HORSHAM DISTRICT COUNCIL CONSULTATION

TO:	Horsham District Council – Planning Dept
LOCATION:	The Copse Worthing Road Horsham West Sussex
DESCRIPTION:	Approval of details reserved by conditions 5, 7, 8 and 9 to approved application DC/24/0622
REFERENCE:	DISC/26/0308
RECOMMENDATION:	Condition 5: No comment Condition 7: Modification Condition 8: No comment Condition 9: Holding Objection / Modification

[LEFT] Layout under DC/24/0622 & DC/26/0255, [RIGHT] Current Drainage Layout

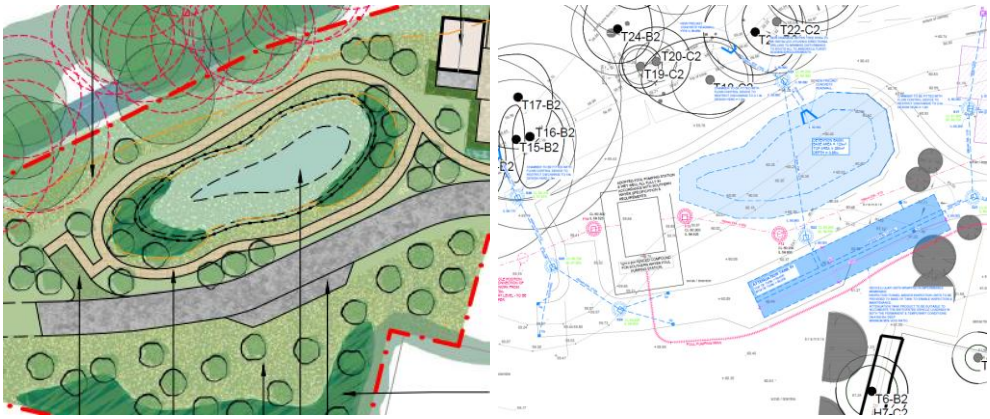
3. Modification is required in order to demonstrate no conflict with the landscape strategy. Please address the following:
    a. Multiple discrepancies are noted within the tree layout. Please amend plans to reflect the most up to date tree layout (see Site Layout and Illustrative Landscape Masterplan under DC/26/0255).
    b. The location of the pumping station has been relocated, resulting in a further reduction in tree provision. Justification is sought as to why it can no longer be provided to the west of the parking area. In any case, the missing trees must be provided elsewhere.

Services Layout

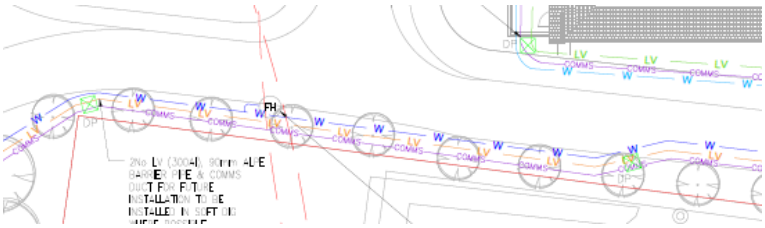
c. Discrepancies in tree layout notwithstanding, amendments must be made to underground services in order to avoid conflicts which are observed throughout the scheme. The access road is highlighted as being of key importance.
